RE: Planning Board Meeting on 5 Feb 2009
CLAREMONT AIS SUBDIVISION
PHASES 4+5
MAJOR MODIFICATION TO
CONDITIONAL USE PERMIT
1001 HOMESTEAD ROAD
CARRBORO NORTH CAROLINA

Date: February 19, 2009
 To: James Thomas, Zoning Development Specialist
 Cc: Roy Williford, Planning Director
 Patricia McGuire, Planning Administrator
 Marty Roupe, Development Review Administrator
 From: R. Dodd Environmental Planner
 Subject: Claremont II Public Hearing response

**SUMMARY SHEET OF STAFF AND ADVISORY BOARD
RECOMMENDATIONS**

**MAJOR MODIFICATION TO CONDITIONAL USE PERMIT FOR
CLAREMONT SUBDIVISION, PHASE IV & V**

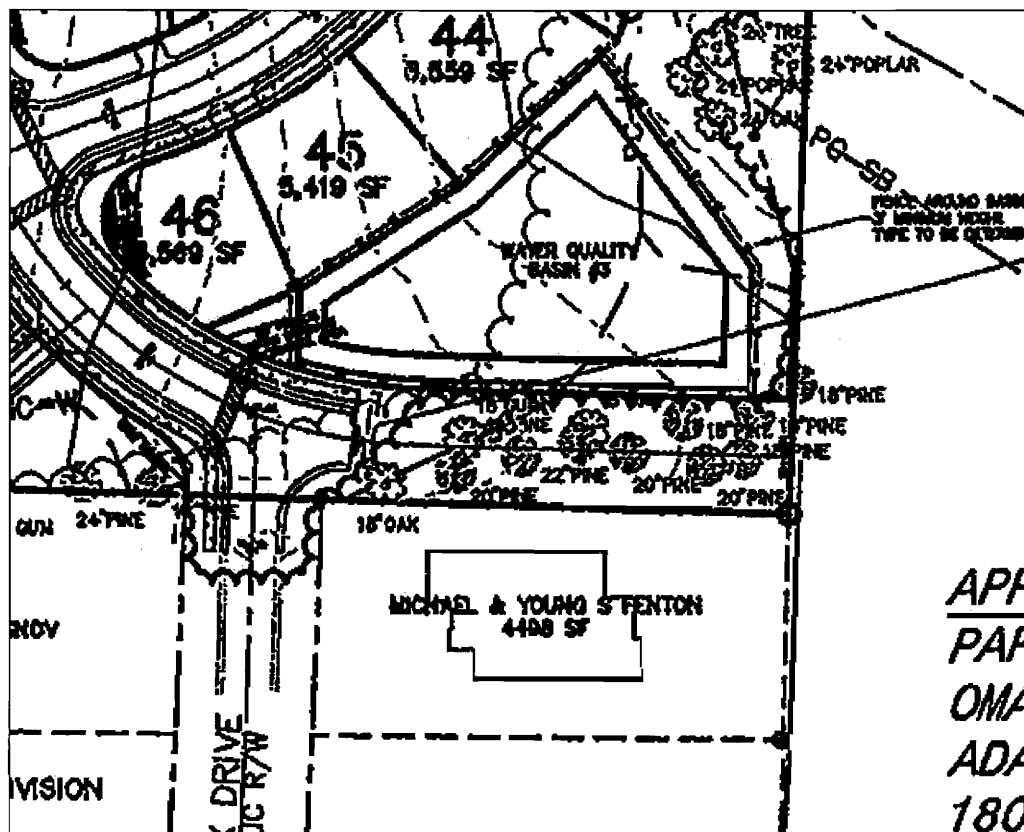
I have been reviewing the plans submitted by the developer (Zinn) and have major concerns about the placement of the Water Quality Basin #3 as shown below:
